Access Compliance Report

Public Rights-of-Way

(Curb Ramps)

Intersection ID: 9648	Main Street: TIMBERBROOK_DR	Cross Street: TUCKASEEGEE_RD	Location: NE
ADA ID: 9CA2A219EEBA	Ramp Type: Para	Initial Pass/Fail: Fail	Overall Compliance: No
Severity Score: 13.75			
Codes/Mitigation Info/Possible Solution		Field Measurements/Component Compliance

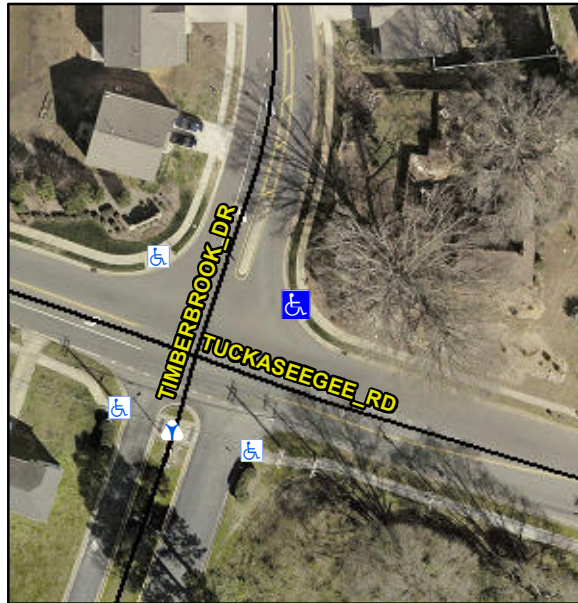
CURB LIP 0.5

R304.5.3, R304.3.2

Compliance	Description	Data	Compliance	Description	Data
N/A	Ramp Length LT (in)	58.5	N/A	Ramp Length RT (in)	54.0
Yes	Ramp Width LT (in)	59.0	Yes	Ramp Width RT (in)	59.0
Yes	Ramp Slope LT (%)	5.1	No	Ramp Slope RT (%)	9.8
No	Ramp XSlope LT (%)	2.8	No	Ramp XSlope RT (%)	2.5
N/A	Landing Length (in)	N/A	N/A	DWS Provided?	N/A
N/A	Landing Width (in)	N/A	N/A	DWS Contrast?	N/A
N/A	Landing Slope (%)	N/A	N/A	DWS Length (in)	N/A
N/A	Landing X Slope (%)	N/A	N/A	DWS Full Width?	N/A
N/A	Landing Curb? (Y/N)	N/A	N/A	DWS Offset (in)	N/A
N/A	Shared Landing?	N/A			
N/A	Gutter Ponding?	N/A	N/A	Gutter Slope (%)	N/A
N/A	Gutter Lip Ht (in)	N/A	N/A	Gutter X Slope (%)	N/A
N/A	Painted X Walk1?	No	N/A	Painted X Walk2?	N/A
	X Walk 1 Direction	To W		X Walk 2 Direction	N/A
N/A	X Walk 1 Width (in)	N/A	N/A	X Walk 2 Width (in)	N/A
	X Walk 1 Slope (%)	0.3		X Walk 2 Slope (%)	N/A
	X Walk 1 X Slope (%)	0.1		X Walk 2 X Slope (%)	N/A
N/A	Ramp inside XWalk1?	N/A	N/A	Ramp inside XWalk2?	N/A

Remove & Replace Entire Ramp.
